**PLEASANT PRAIRIE PLAN COMMISSION MEETING
VILLAGE HALL AUDITORIUM
9915 39th AVENUE
PLEASANT PRAIRIE, WISCONSIN
6:00 P.M.
APRIL 14, 2014**

Consider the request of Mark Molinaro, Jr. of Partners In Design Architects, agent on behalf of the Hospice Alliance Foundation, Inc. for approval of **Site and Operational Plans** to expand the parking for their facility located at 10220 Prairie Ridge Blvd.

HOSPICE ALLIANCE PARKING LOT EXPANSION
 Pleasant Prairie, Wisconsin
Architectural Site Plan

SHEET NUMBER:
 C-4.0

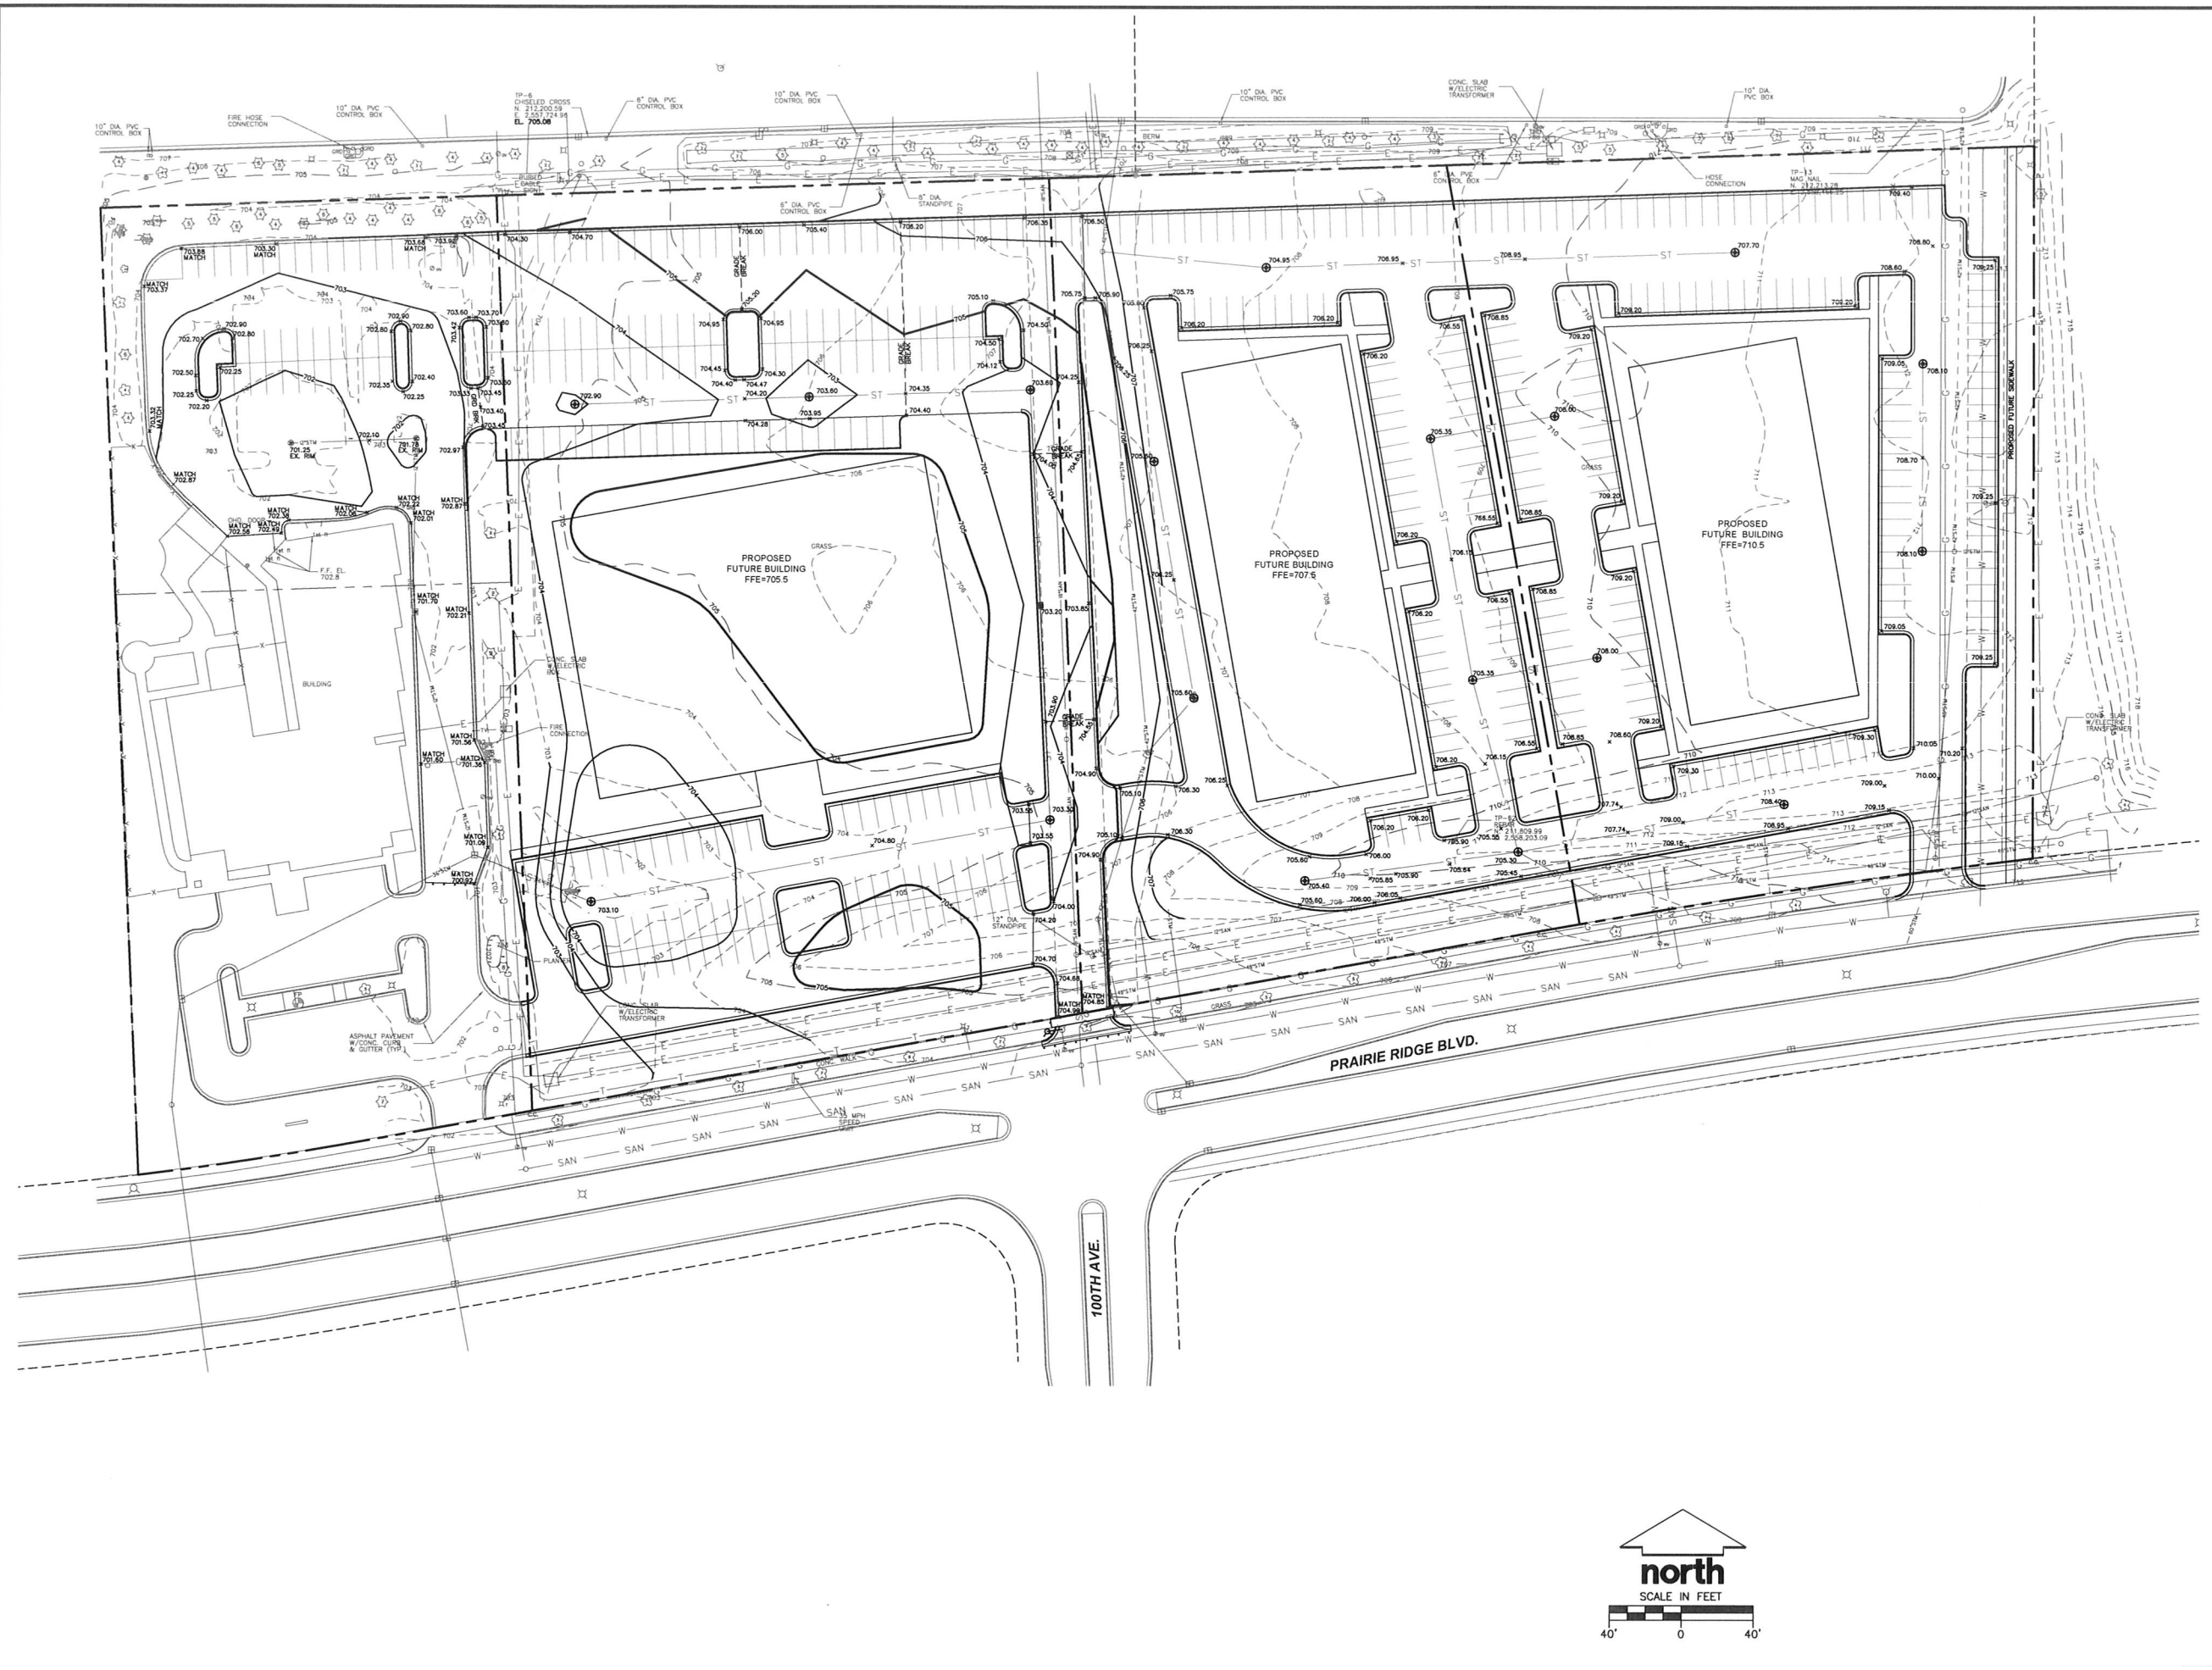
- c. Dimension the setback of the newly proposed parking lot to the north property line.
 - d. Plan Sheet A1.1 depicts curb and gutter along the south side of the new east parking area, while Plan Sheet C-4.0 depicts no curb and gutter in this location due to the possible construction of "25 future parking spaces". Either this area needs to be curbed and guttered with the construction of the expanded parking,

l. Site Layout and Pavement ID Plan

- i. The new drive entrance to Prairie Ridge Boulevard shall have a depressed curb. Also, a concrete drive approach shall be provided up to the sidewalk. The plans shall be revised accordingly and details provided.

- Will the curb inlet be initially set to binder grade? Address in plans.
 - The asphalt at the edge of the sidewalk will need to be temporarily ramped with the binder lift.

SITE DETAILS

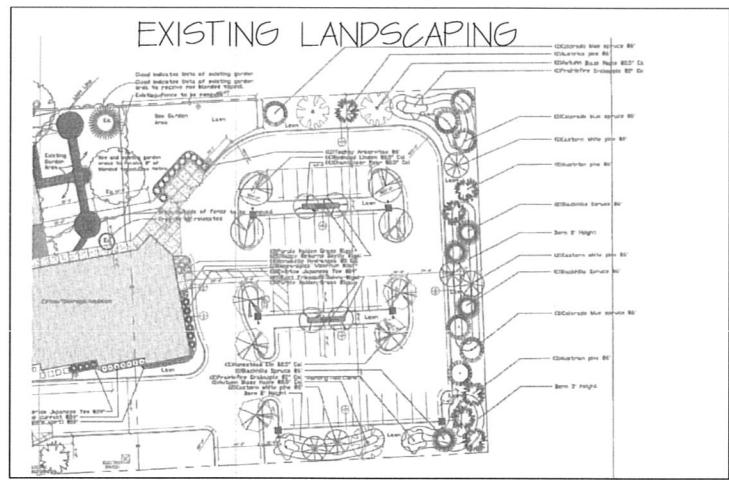
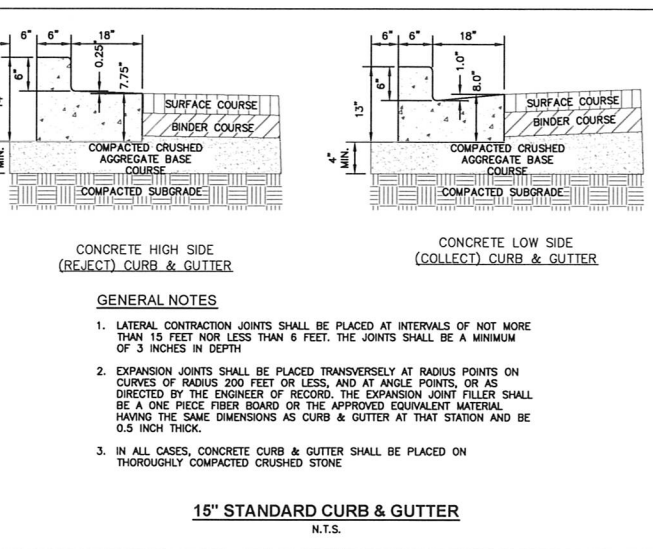
m. Site Details

- i. Revise the driveway entrance detail to match existing site conditions and specifications.
 - ii. Replace the hydrant assembly detail with the Village’s updated detail, a copy of which is ***attached***.
- 4. The existing sanitary sewer shall be televised by the Village of Pleasant Prairie and the owner shall make any repairs prior to hard surface installed. Contact Village Public Works Department at 262-925-6700 to request the televising. *Note on the plans.*
 - 5. Upon approval of the revised plans, an electronic pdf of all plans shall be submitted to the Village with three (3) full size copies of the plans.
 - 6. Written approval from the Prairie Ridge Commercial Owners Association is required for any parking lot expansion. A copy of the written approval shall be provided to the Village prior to issuance of the required permits.
